Fiat Scudo - Onvoldoende capaciteit van het aircosysteem | HELLA

Scudo 1,6D Multijet 90

Bouwjaar: vanaf 2007 tot en met VIN 84160387

Onvoldoende capaciteit van het aircosysteem

- Oude uitvoering -

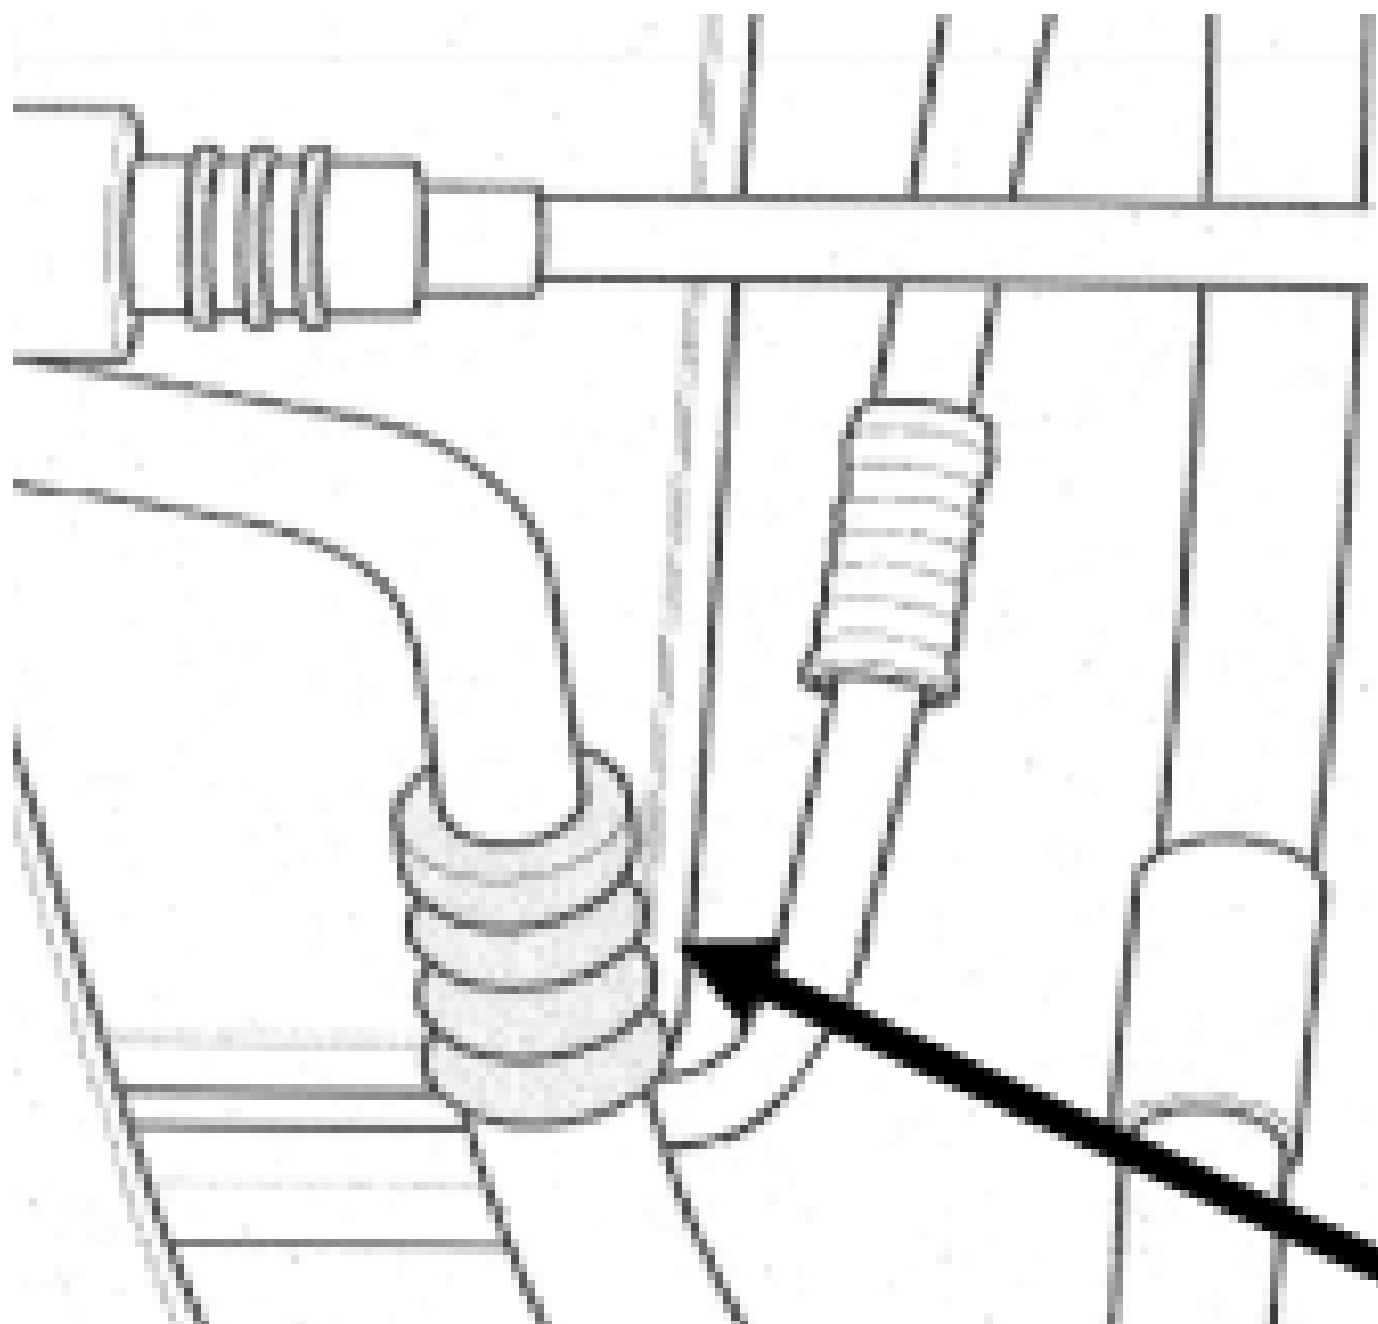
Wordt bij de bovengenoemde voertuigen een onvoldoende koelcapaciteit resp. een koudemiddelverlies vastgesteld, kan dit worden veroorzaakt door een lekkage in de koudemiddelleiding tussen condensor en compressor.

De koudemiddelaansluiting op de juiste uitvoering controleren en evt. vervangen. (Zie afbeeldingen)

De voertuigfabrikant heeft hiervoor een gewijzigde uitvoering [Reserveonderdelen (RO)]

- 1 stuks: Koudemiddelleiding (RO): 140142280

- 2 stuks: O-ring: (RO): 9645950980
